Date: October 13, 2022
To: Tillamook County Planning Commission
From: Sarah Absher, CFM, Director
Subject: Riverview Meadows Phase 2 Subdivision Request #851-21-000415-PLNG

#851-21-000415-PLNG: Request for tentative subdivision plat approval of "Riverview Meadows Phase 2", a 38-lot subdivision proposed on a property located within the City of Nehalem Urban Growth Boundary together with Geologic Hazard Report for Riverview Meadows Phase 2, #851-21-000414-PLNG. The subject property is zoned Nehalem Medium-Density Residential (NH_R1) and Nehalem Residential Trailer (NH_Rt). The subject property is accessed via Riverview Meadows Lane, a private road, and designated as Tax Lot 3600 of Section 23B, Township 3 North, Range 10 West of the Willamette Meridian, Tillamook County, Oregon.

Re: Riverview Meadows Phase II - Response to 12/13/21 Incompleteness Letter

#5

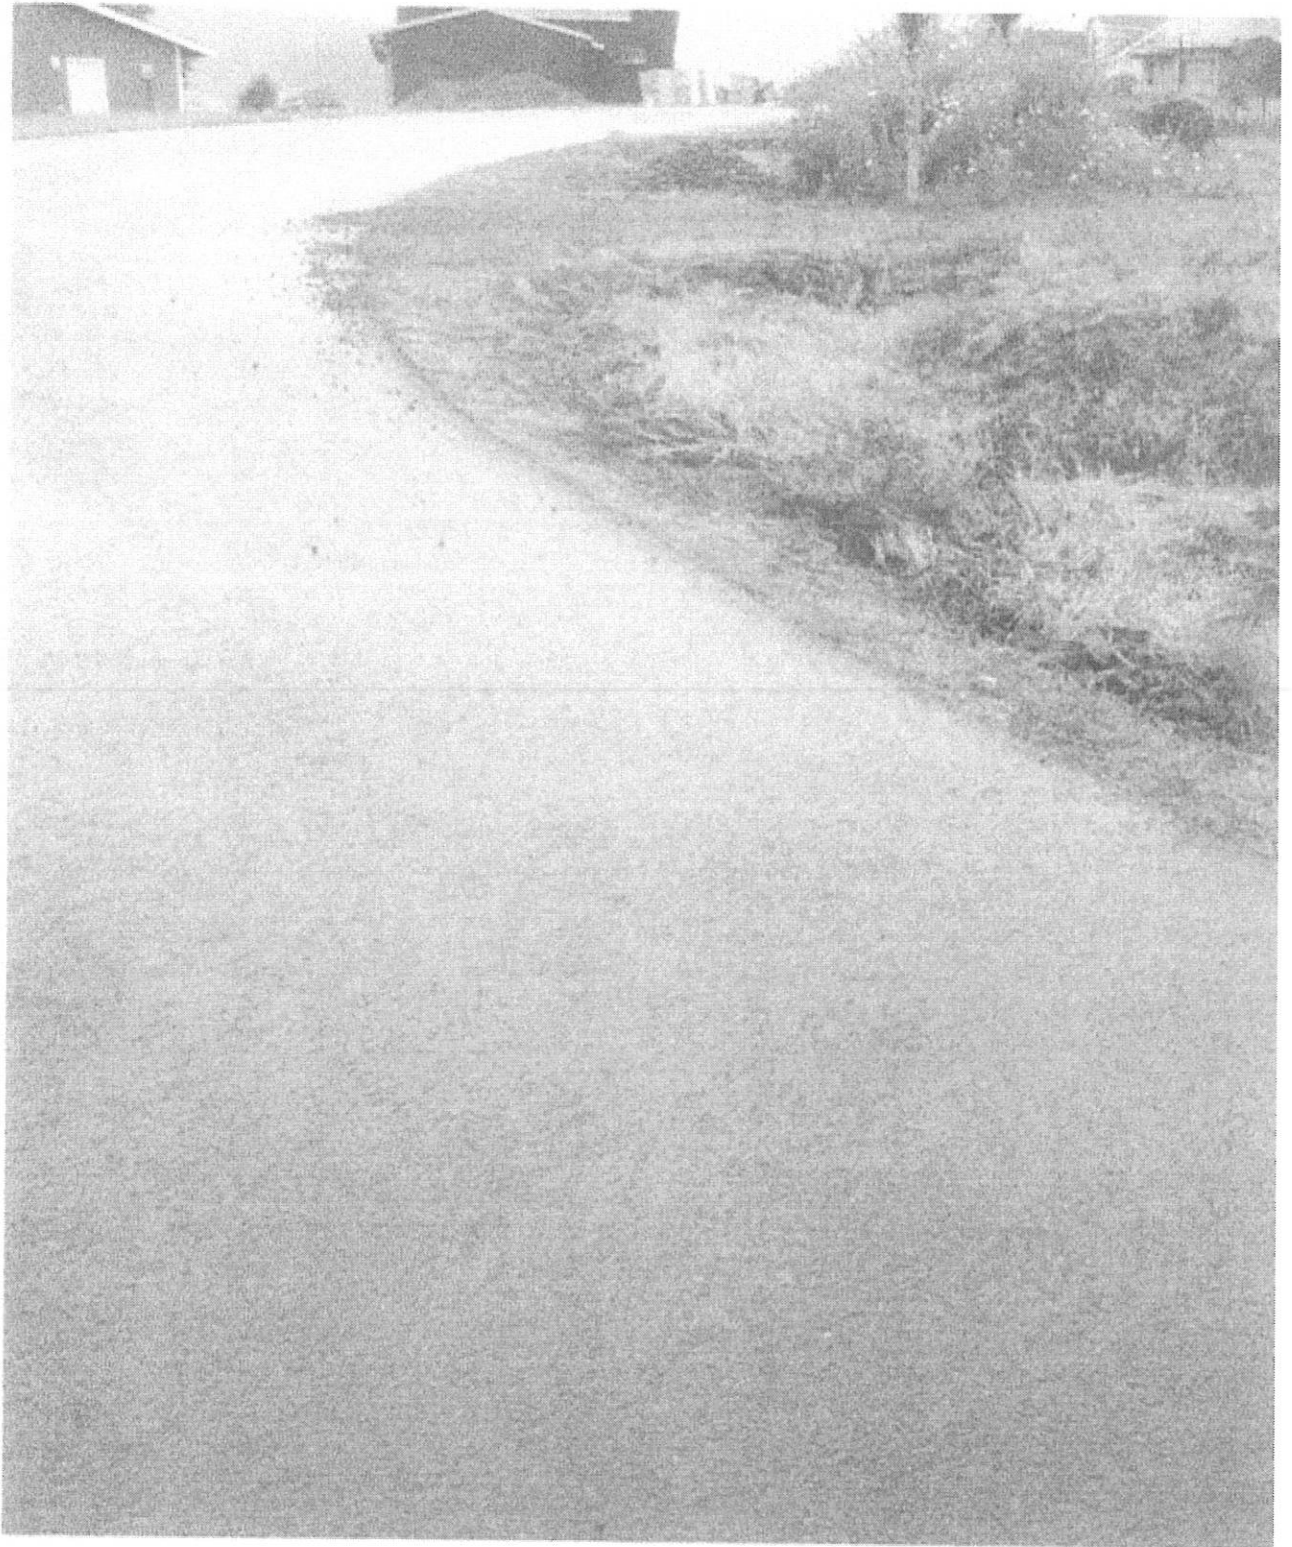
The eastern edge of Riverview Meadows Ln. has a road shoulder of 4 feet before it drops 12 degrees. Since there are no guard rails, if a vehicle were to meet another vehicle, they would roll over, leaving the road surface. The car would then roll down the hillside into our home built on only the car occupants, but any of our family present. With the excessive downhill speed on this road, it is an accident waiting to happen. (see photo # 5)

RIVERVIEW MEADOWS DEVELOPMENT, LLC
RIVERVIEW MEADOWS PHASE 2
DRAINAGE LAYOUT

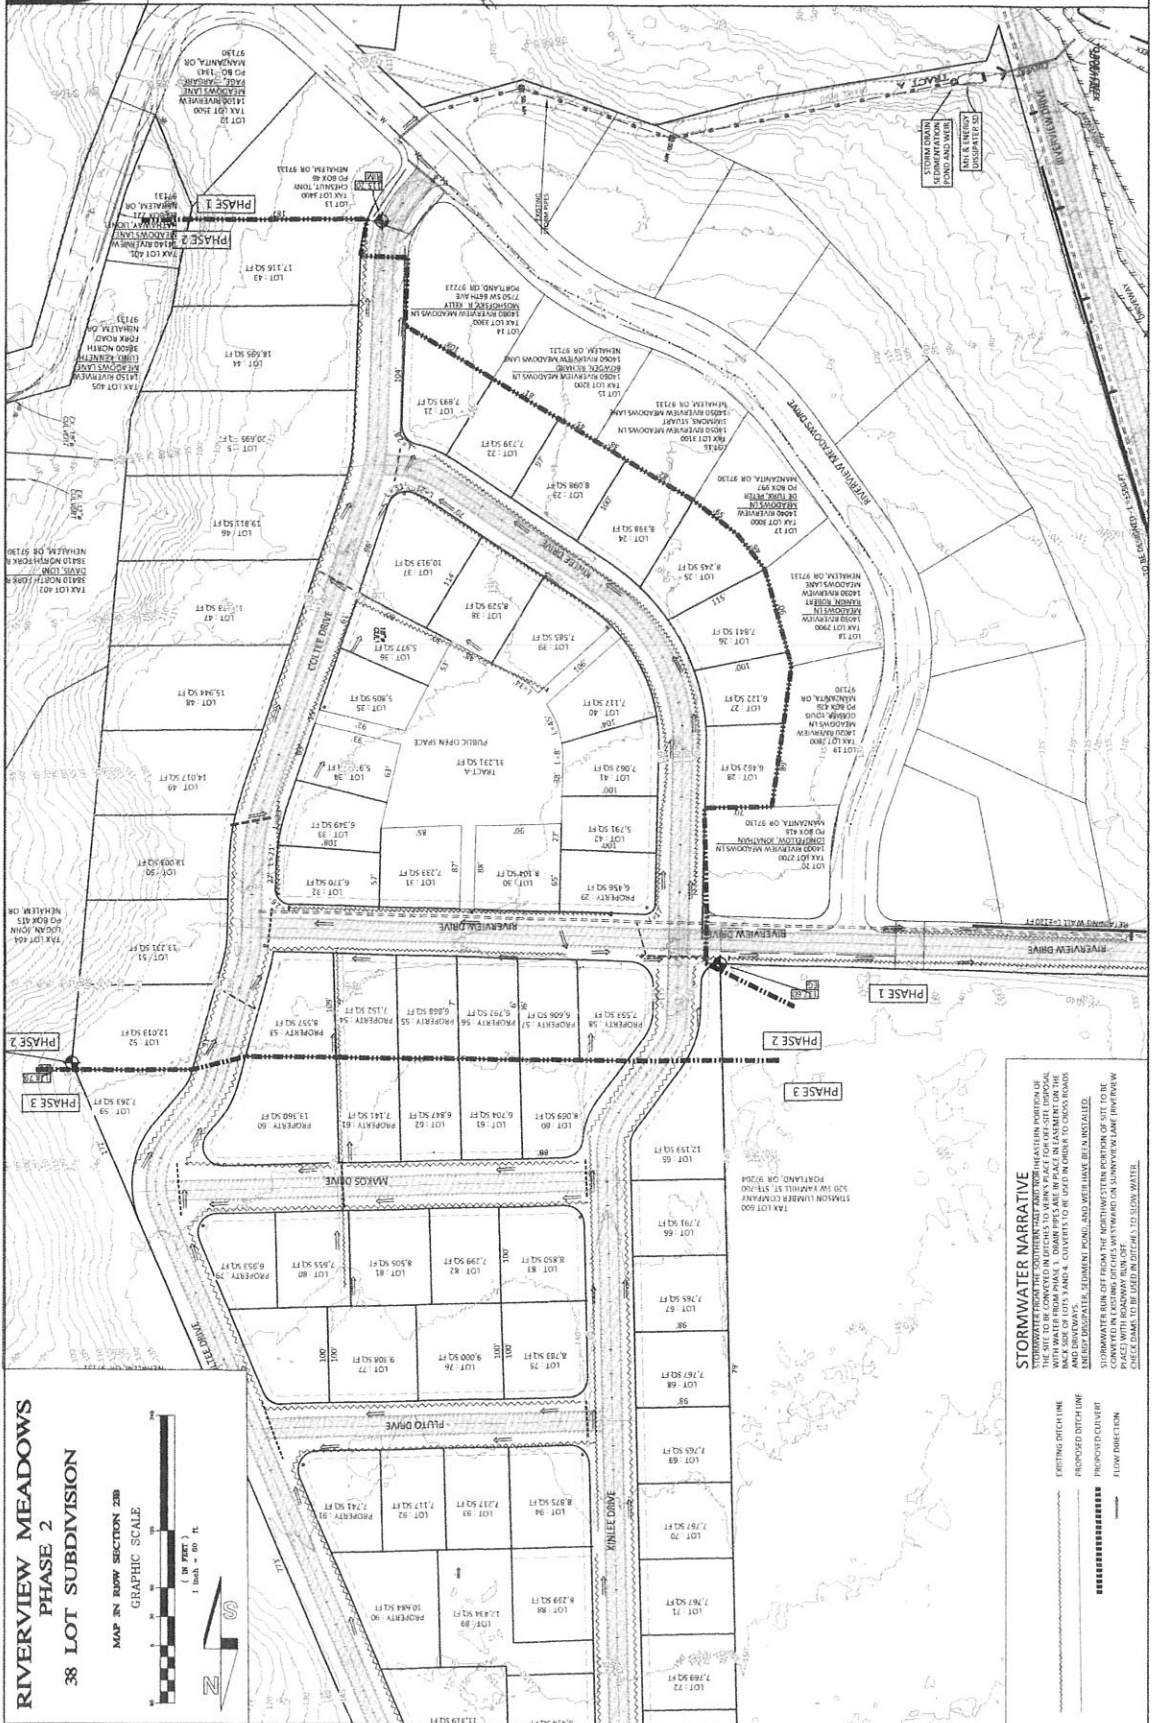
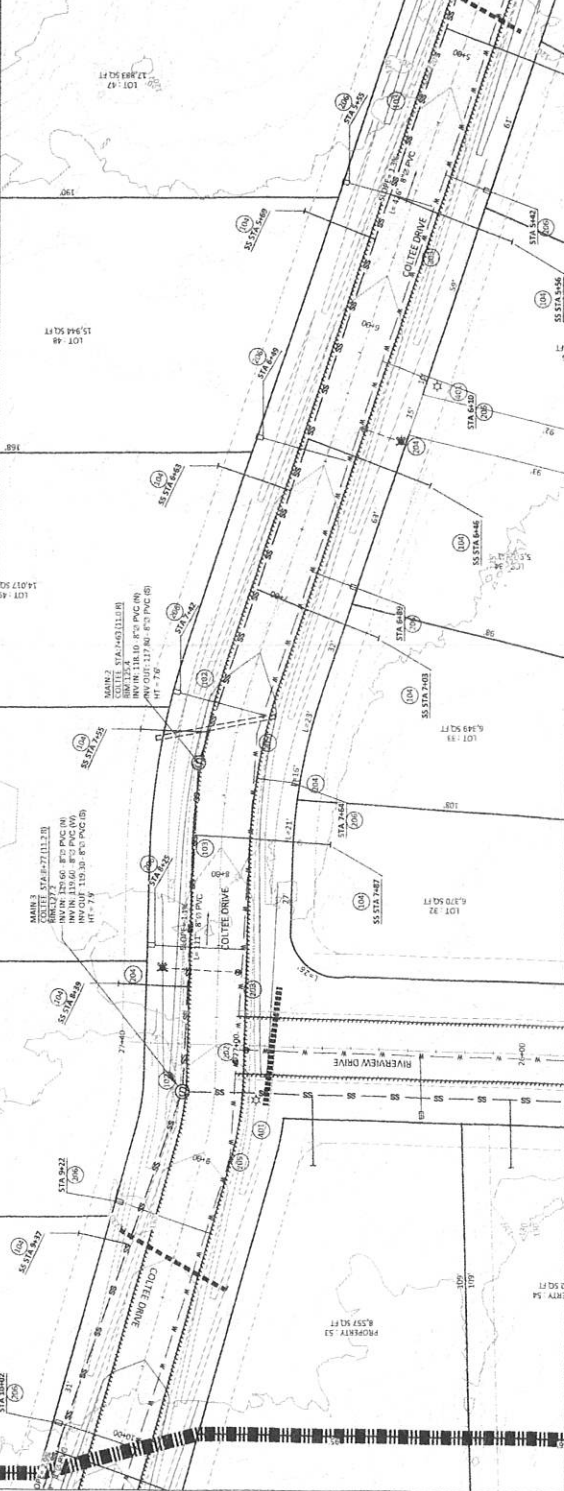
The tentative plat does not adequately illustrate proposed storm water abatement. Details such as sheet-flow directions, swales, infiltration, and detention areas are missing or insufficient. The project Statement does not adequately address all the elements of CNCO 157.261(H)1-6 The project Statement should specifically address each element (1-6) individually or be done so in a detailed storm water management plan developed and reviewed by a qualified professional for adherence to the Geological Hazard Report and the requirements of CNCO Section 157.261 *et.al.*

Response: *Sheet 3 of the plan set shows the proposed stormwater conveyance and discharge plan. The plan utilizes a combination of existing ditches, newly constructed roadside ditches, and culverts to convey stormwater to existing stormwater discharge points established with Phase I. Arrows on the plan show the proposed direction of stormwater flow. In addition, a road cross-section has been added to the plan set showing roadside ditches are proposed along both sides of roads.*

SHEET 3b
 of TWENTY

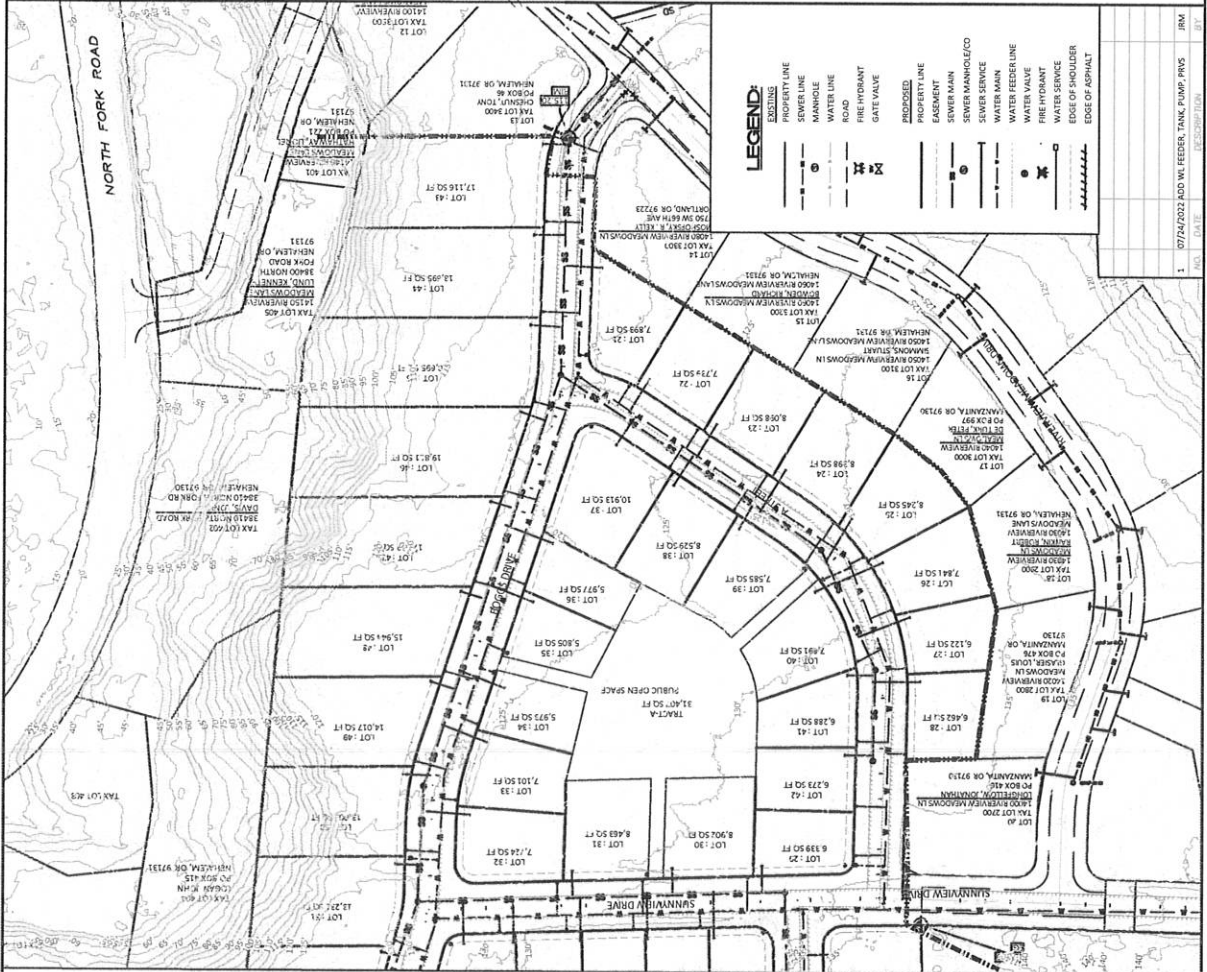
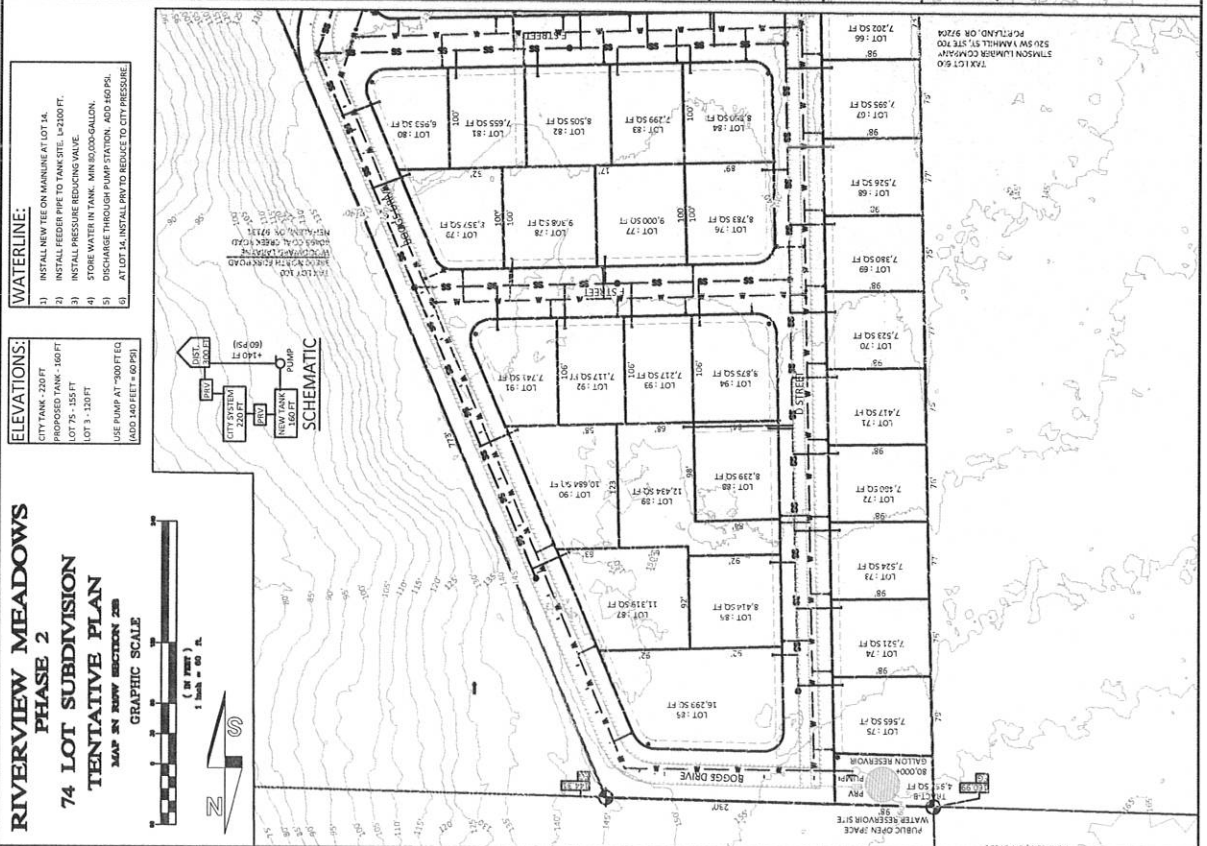
The feeder line, tank, and PRV are shown on the attached drawing in red.

- WATERLINE:**
- INSTALL NEW 72" ON MAINLINE AT LOT 14.
 - INSTALL FEEDER PIPE TO TANK CELL L4300 FT.
 - INSTALL PRESSURE REDUCING VALVE LOT 1.
 - STORE WATER IN TANK. MIN 800 GALLON.
 - DISCHARGE THROUGH PUMP STATION. 800 GAL PPL.
 - AT LOT 14, INSTALL DRIV TO REDUCE TO CITY PRESSURE.
